**APPLICATION AND
PRELIMINARY PLAT CHECKLIST**

NAME OF PROPOSED SUBDIVISION The Shores Phase Four

PRELIMINARY PLAT

Agenda Item: **P&Z 93-3-PP** - Discuss and Consider Approval of a Preliminary Plat for Phase 4, Shores, a 26 lot Subdivision South of Ridge Road West

PRELIMINARY PLAT

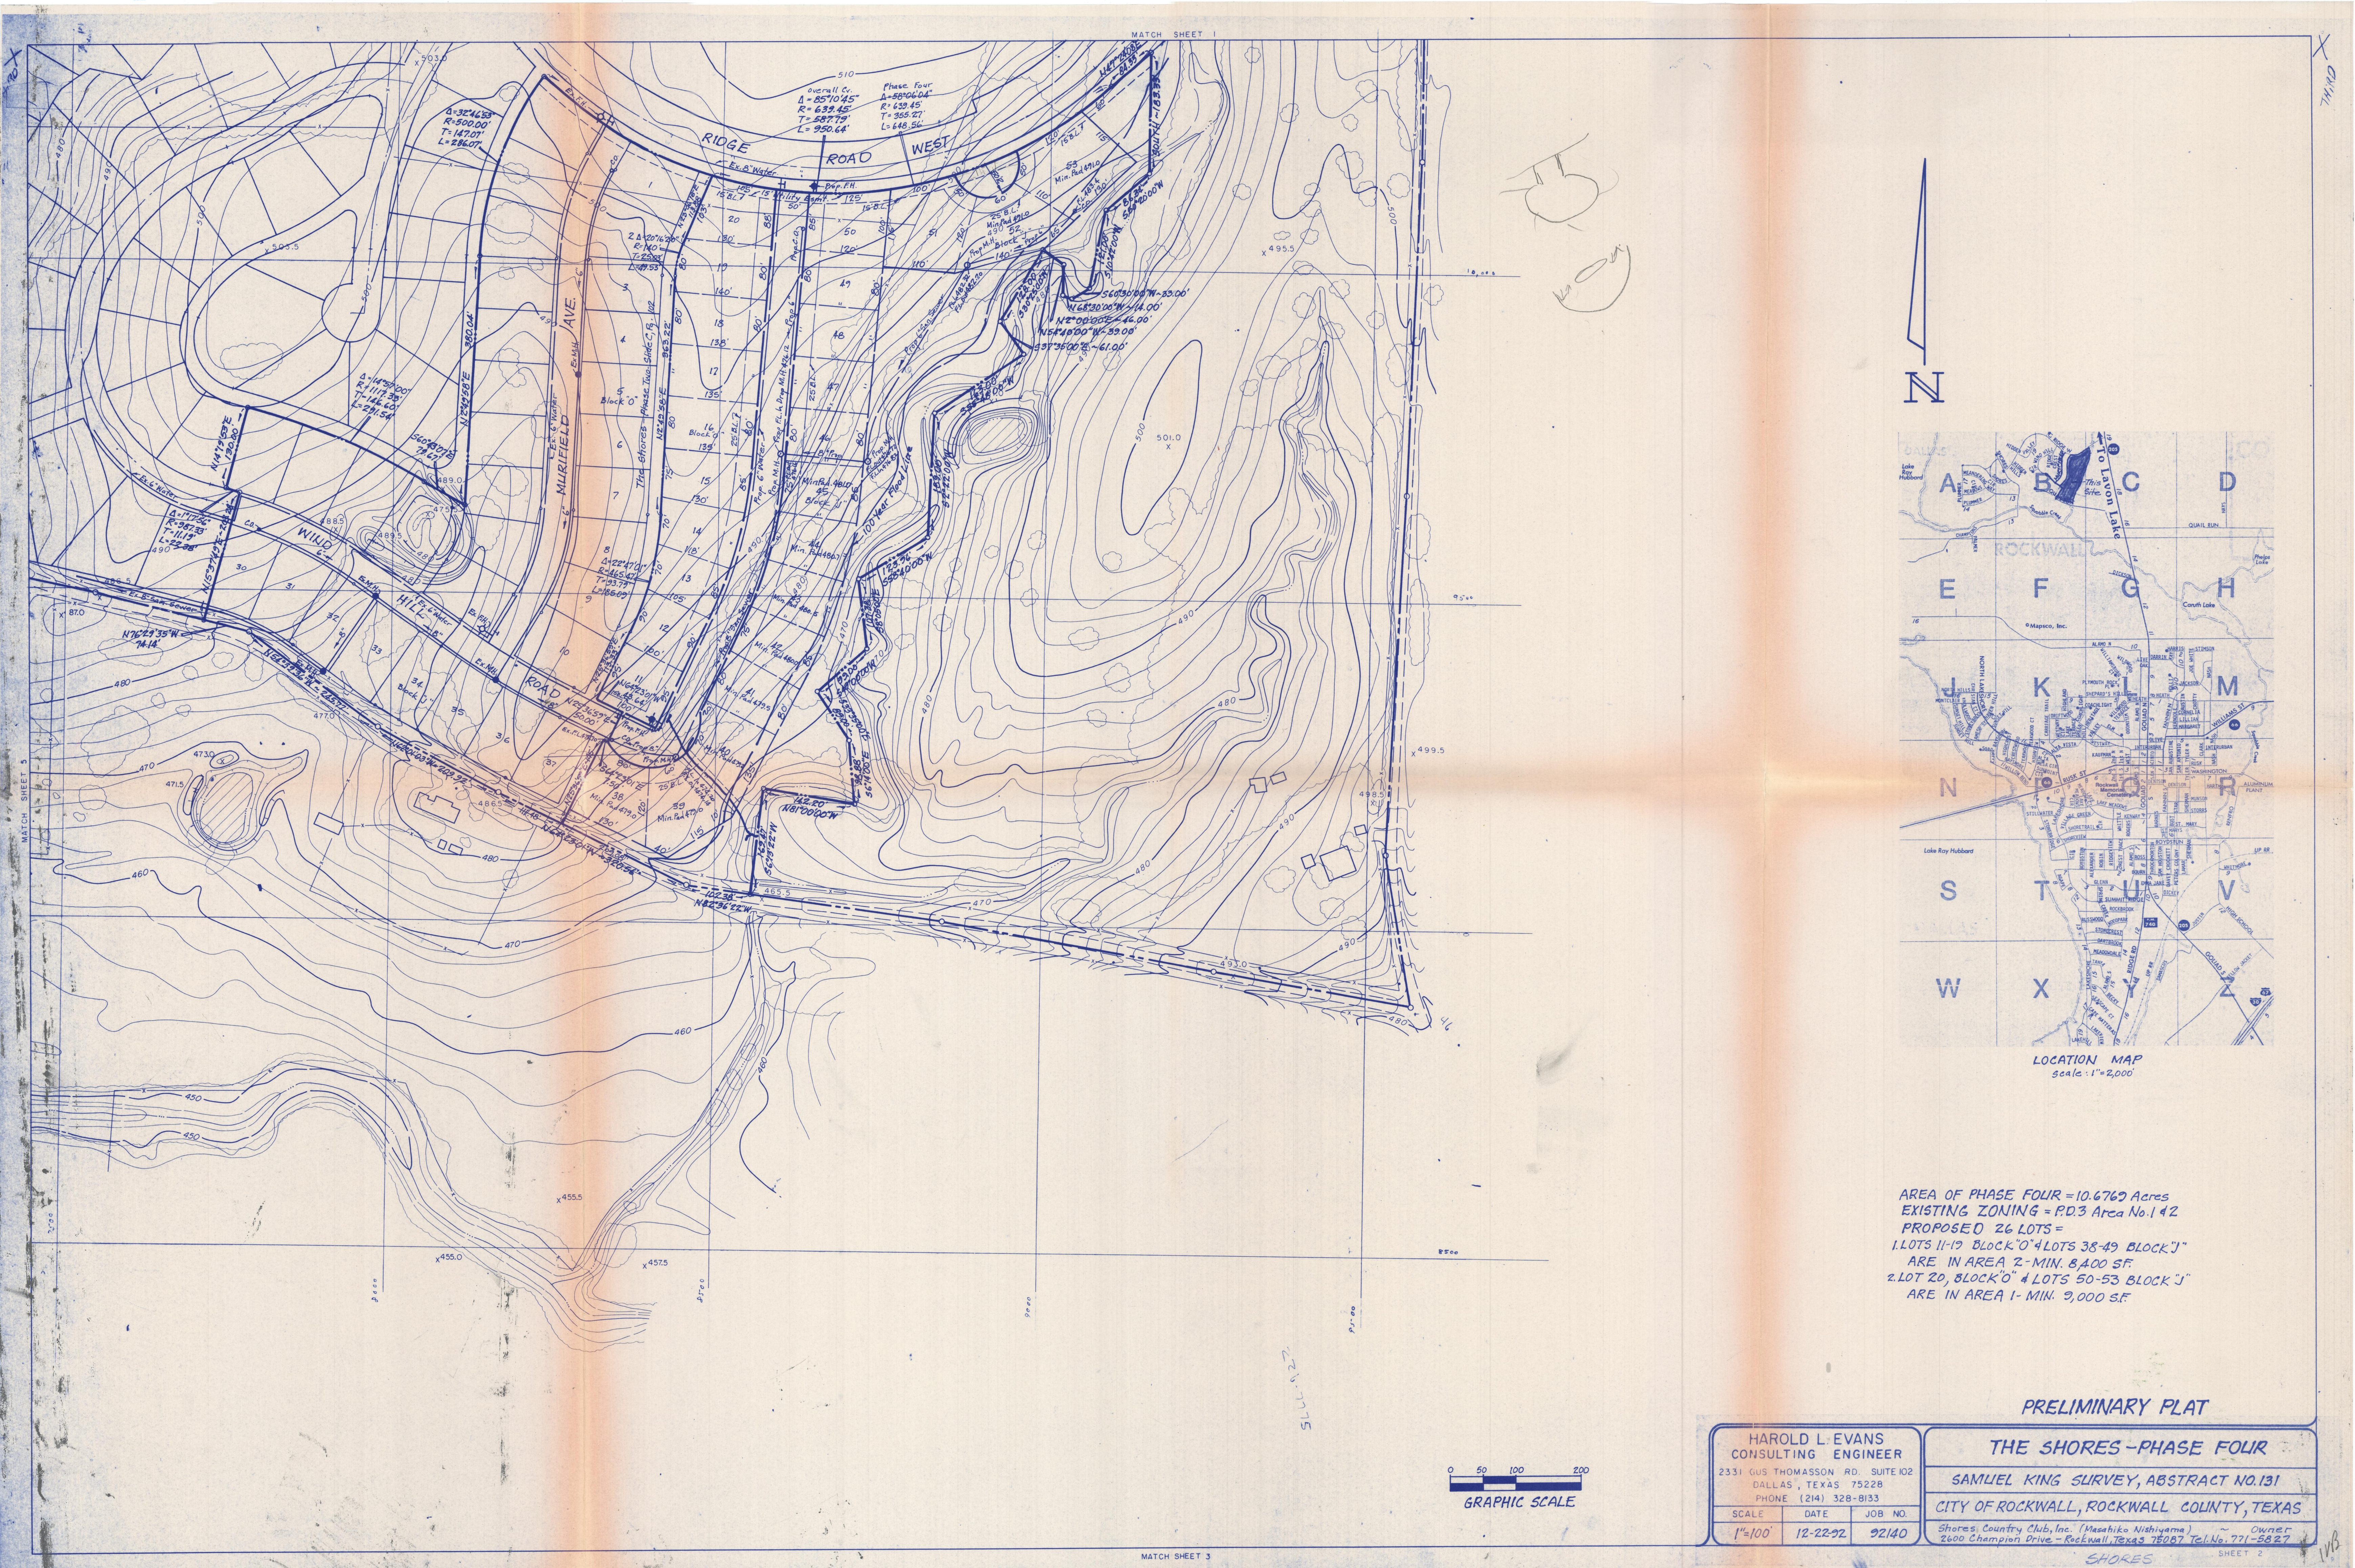
1. Need utility fee
2. Need lot sizes
3. Greenbelt area specified around 89-4 as owner maintained & to be developed w/ mt fact
4. Alley behind lots 51-53 / alternative
5. Options on drainage area use
 1. owner maintained / common area
 2. Inoperator into lots
 3. City maintained -
use as city property - ~~that~~
 - a. drainage only
 - b. access to trail system
 - c. develop as a trail system
6. Need to do a flood study on drainage area
7. Dedication of Quail Run Rd.
8. Easement for Quail Run Rd.
9. Does continuation as a end hill Road work for street addressing
10. Width of alleys behind drainage area.
11. Adequate access for drainage purposes
